Access Compliance Report Public Rights-of-Way (Curb Ramps)

Main Street: OAKTREE Cross Street: OAKTREE Location: SE

ADA ID: RPRK220225180658 Ramp Type: Type 4 - Parallel Initial Pass/Fail: Fail Overall Compliance: No Severity Score: 45

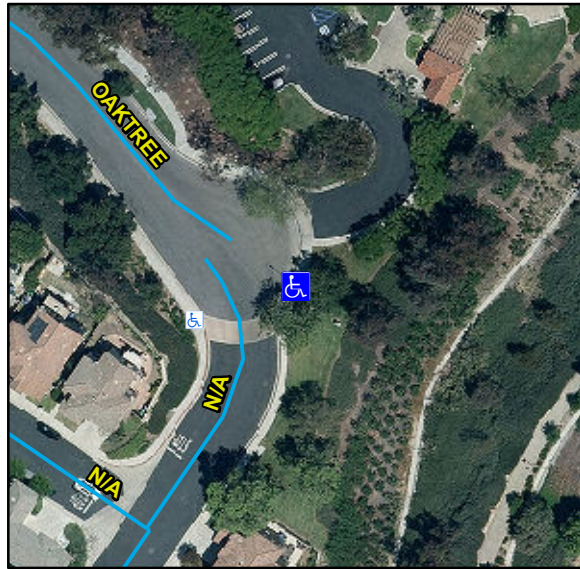
R304.5.3, R304.3.2, STD 1115

Compliance	Description	Data	Compliance	Description	Data
N/A	Ramp Length LT (in)	67	N/A	Ramp Length RT (in)	72
Yes	Ramp Width LT (in)	66	Yes	Ramp Width RT (in)	66
Yes	Ramp Run Slope LT (%)	3.8	No	Ramp Run Slope RT (%)	16.6
No	Ramp Cross Slope LT (%)	5.5	Yes	Ramp Cross Slope RT (%)	1.9
N/A	Landing Present	N/A	N/A	DWS Provided	N/A
N/A	Landing Length (in)	N/A	N/A	DWS Contrast	N/A
N/A	Landing Width (in)	N/A	N/A	DWS Length (in)	N/A
N/A	Landing Run Slope (%)	N/A	N/A	DWS Full Width	N/A
N/A	Landing Cross Slope (%)	N/A		DWS Offset Type	N/A
N/A	Landing Movement Obstructed?	N/A	N/A	DWS Offset Left (in)	N/A
	Landing Movement Type	N/A	N/A	DWS Offset Right (in)	N/A
N/A	Landing Shared	N/A			
N/A	Clear Space	N/A			
N/A	Clear Space To Crosswalk (in)	N/A			
N/A	Marked Crosswalk 1	No	N/A	Marked Crosswalk 2	N/A
	Crossing 1 Direction	W		Crossing 2 Direction	N/A
	Marked Crosswalk 1 Width (in)	N/A		Marked Crosswalk 2 Width (in)	N/A

Remove & Replace Entire Ramp.
